# Town of Mammoth Lakes

### Commission Staff Report

<b>Date:</b>	June 14, 2017	<b>File No.:</b>	Design Review (DR) 16-012; Lot Line Adjustment (LLA) 16-002
<b>Place:</b>	Council Chambers, 2 <sup>nd</sup> Floor Minaret Village Shopping Center Mammoth Lakes, CA 93546	<b>Project:</b>	Grocery Outlet
<b>Time:</b>	After 2:00 p.m.	<b>General Plan:</b>	Commercial 2 (C-2)
<b>Appeal Status:</b>	Appealable to the Town Council	<b>Specific Plan:</b>	N/A
<b>Applicant / Owner:</b>	Best Development Group / Vereuck Rev. Trust	<b>Zoning:</b>	Downtown (D)
<b>Environmental Review:</b>	Categorical Exemption (CEQA Guidelines Section 15332 – In-Fill Development Projects)	<b>Location:</b>	37 and 77 Old Mammoth Road

**TITLE:** Consider approval of Design Review 16-012 and Lot Line Adjustment 16-002 for the construction of an approximately 18,000 square foot Grocery Outlet store located at 37 and 77 Old Mammoth Road.

**EXTERIOR ELEVATIONS**

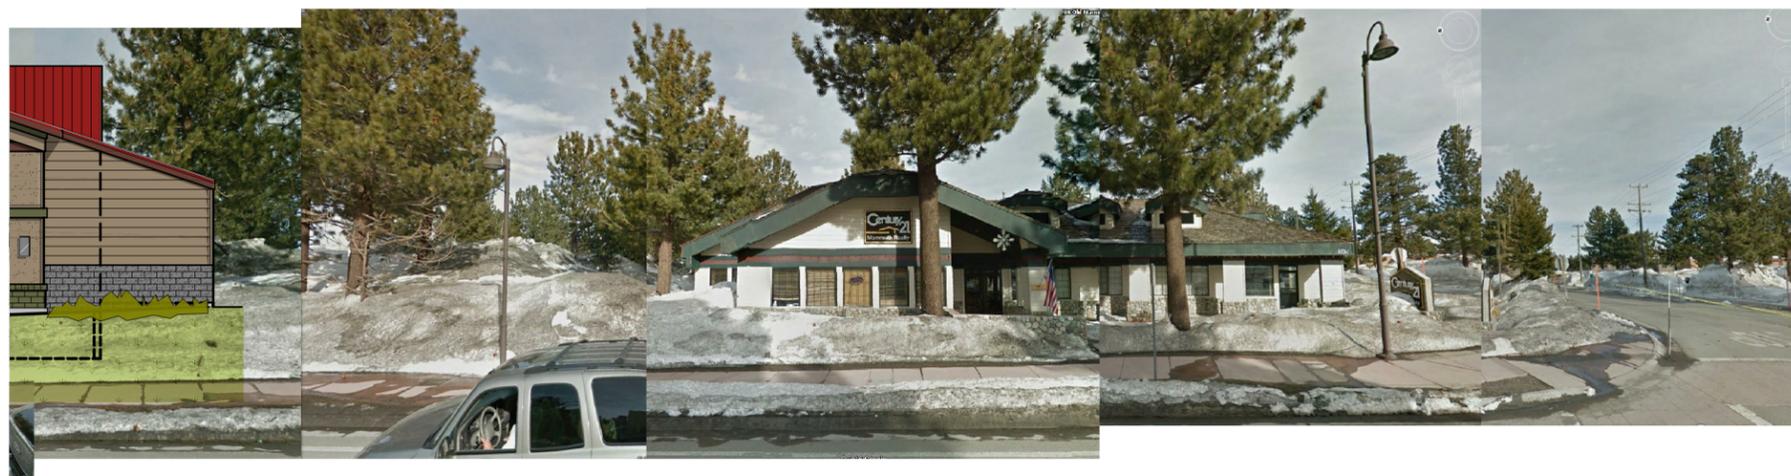
Comment	Response / Revised
The pitched roof on the parapet is a desirable architectural feature, however, there are concerns that snow will shed into the pedestrian areas.	The applicant indicated that the pitched roof is at a relatively low angle (4:12) and there are landscaped areas below that will provide a buffer between the building and the sidewalk. Additionally, snow rails will be installed along the roof edge and a snow fence will be installed adjacent to the bus stop area to further protect the pedestrian area.
The proposed colors are generally consistent with the color handbook, but slightly darker shades would be desirable.	The original submittal proposed tan and ivory as the primary building colors. Based on the Design Committee and staff's comments, the applicant revised the building colors and proposed colors that were darker and more appropriate for the area. The revised colors are consistent with the Color Handbook and the Design Guidelines. See Attachment 2 – Materials Board for the proposed colors and Sheet A6 for the colored elevations.

The southwest corner of the building needs additional articulation so that it complements the rest of the building ( <i>The original building elevations reviewed by the Design Committee had a flat roof with no gable on the southwest corner</i> ).	The applicant revised the southwest corner of the building and added an additional gable roof section so that it matched the other portions of the building. The Design Committee reviewed this modification at the May 11 <sup>th</sup> meeting.

The Design Committee was supportive of moving the Project forward to the PEDC for consideration with the condition of approval that the final metal artwork design would come back to the Design Committee for final approval. All of the above items have been addressed and the modifications are shown in the attached project plans (Attachment 2).

**37 OLD MAMMOTH ROAD**  
**PRELIMINARY GRADING AND DRAINAGE PLAN**  
 TOWN OF MAMMOTH LAKES, MONO COUNTY, STATE OF CALIFORNIA

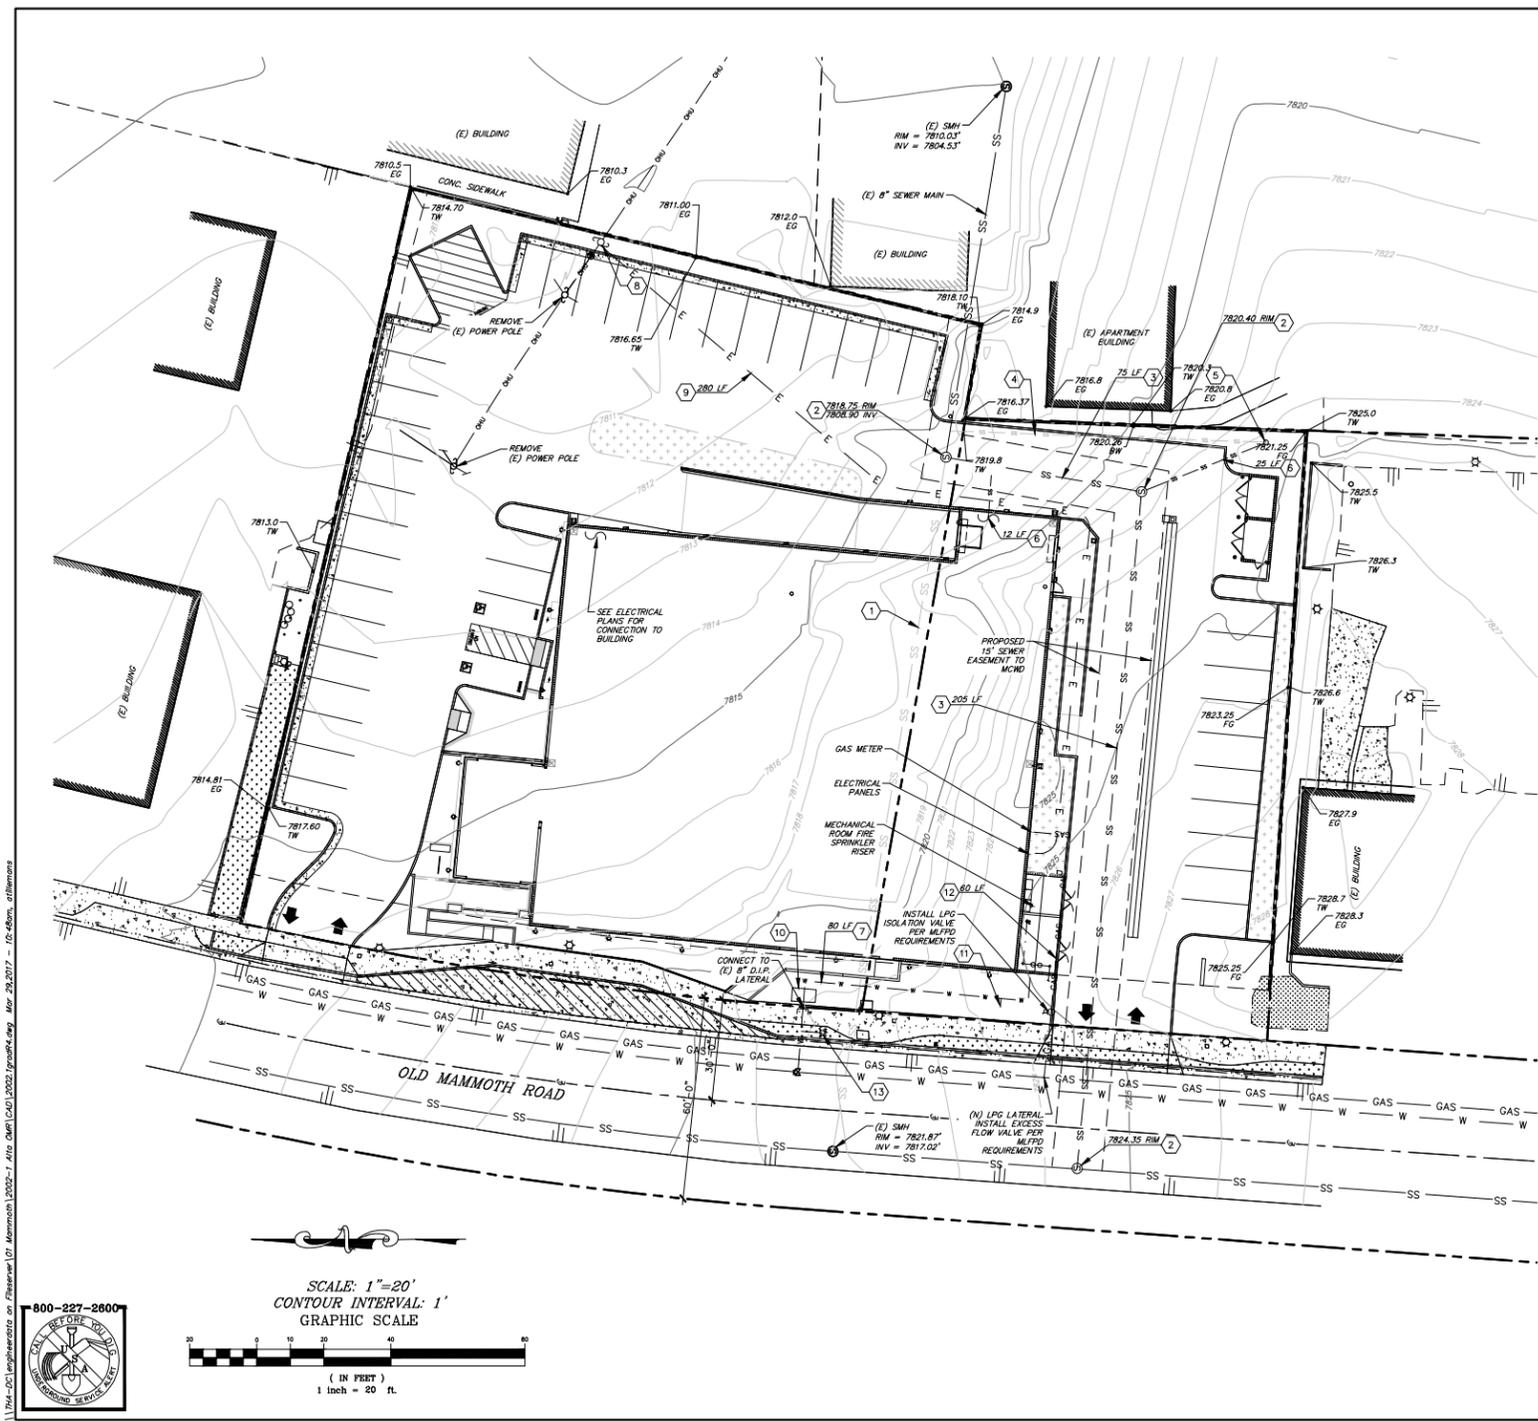
17. Sheet C2 indicates that the propane gas line runs under the slab of the structure the full length of the building to reach the meter on the south side of the structure. This may need to be reevaluated.
